Fiat **Punto (188)** **Model year: from 1999** **With air conditioning**

Compressor noises

Bulletin

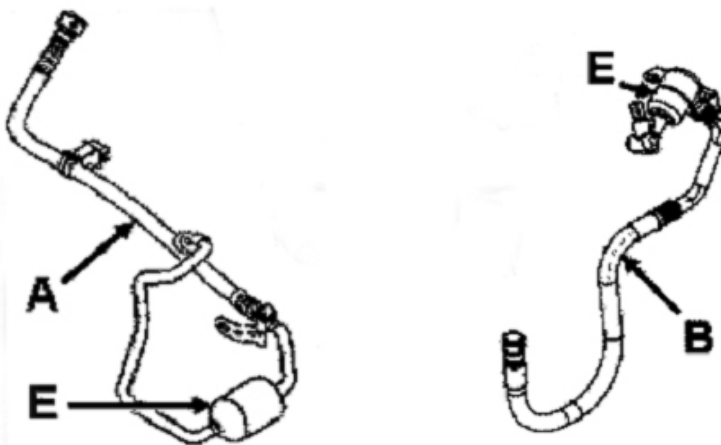
With the above-mentioned vehicles, non-typical noises can occur with the air conditioning switched on, indicating compressor damage. The noises are often not caused by the compressor, however, but rather by the refrigerant pipes. The noises can be caused by resonance. For this reason, the vehicle manufacturer has modified the high and low-pressure lines (drawings, pos. A + B) and integrated a noise muffler (drawings, pos. E).

To ensure that the noises are not caused by the incorrect refrigerant quantity or air bubbles, the air-conditioning system should be serviced before replacement, and the high pressure and low pressure checked over.
